PROPOSED DEVELOPMENT PLAN OF
MARTINEZ ESTATES
AT BRENTWOOD, TOWN OF ISLIP,
SUFFOLK COUNTY, NEW YORK

APPROVED AS NOTED
Town Engineer
TOWN OF ISLIP
DATE 6-28-2021

361 & 365 AMERICAN BOULEVARD, BRENTWOOD
(MS2017-003)

Q130-17
DEVELOPMENT PLAN

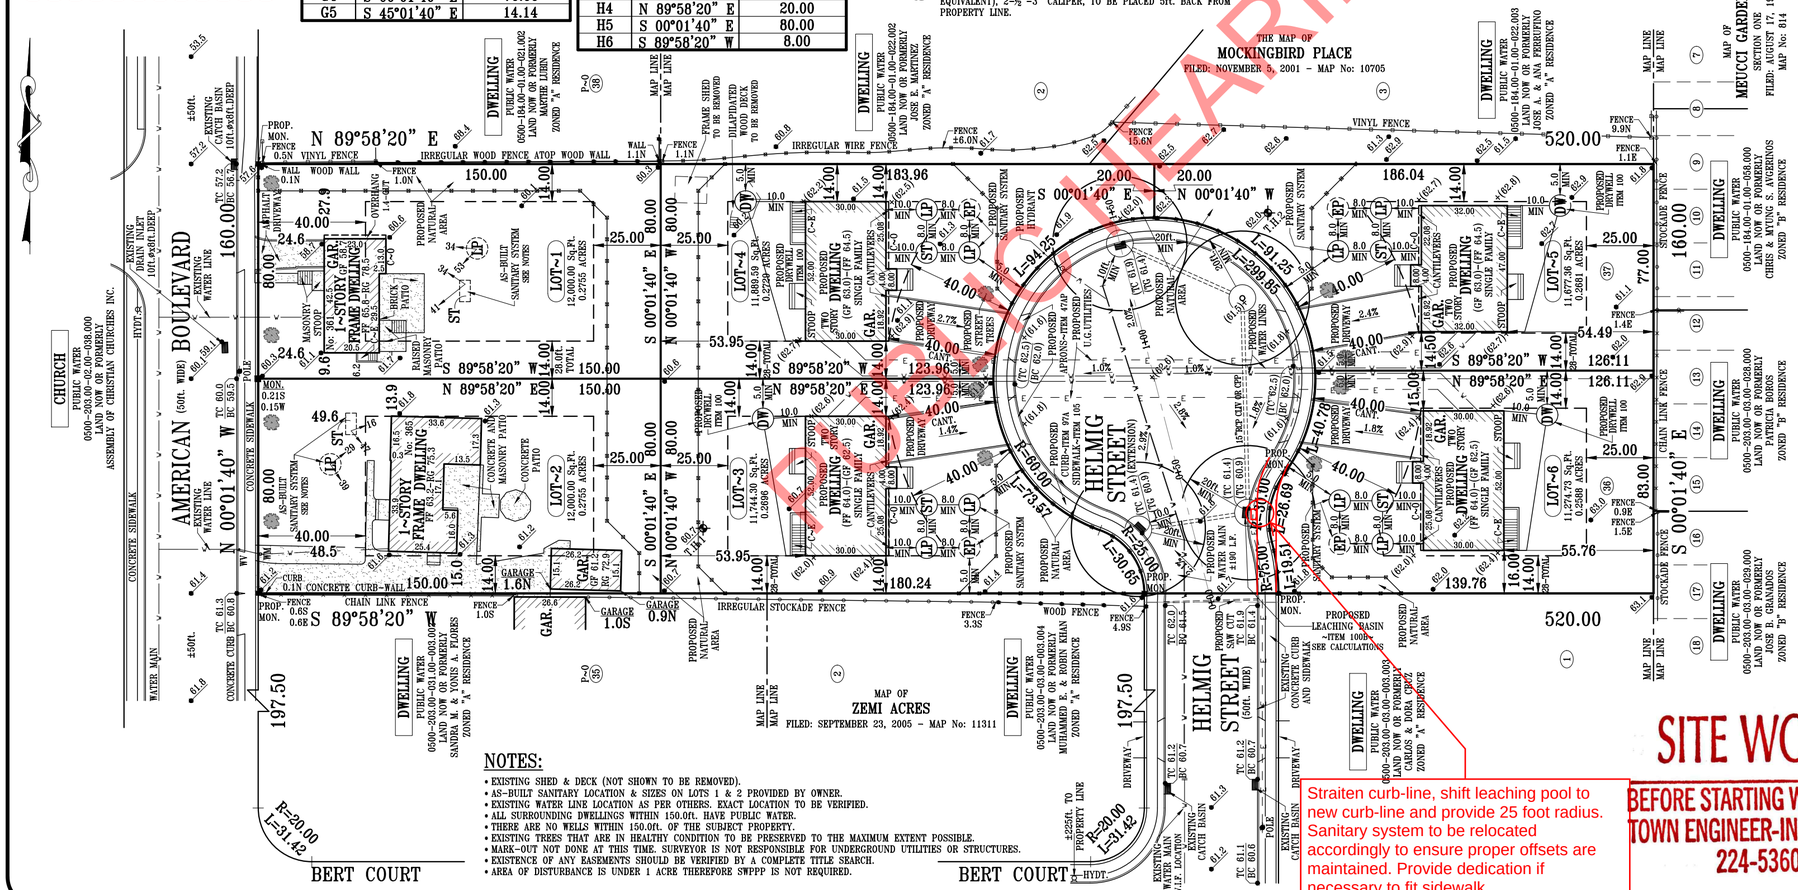
Straiten curb-line, shift leaching pool to new curb-line and provide 25 foot radius. Sanitary system to be relocated accordingly to ensure proper offsets are maintained. Provide dedication if necessary to fit sidewalk.
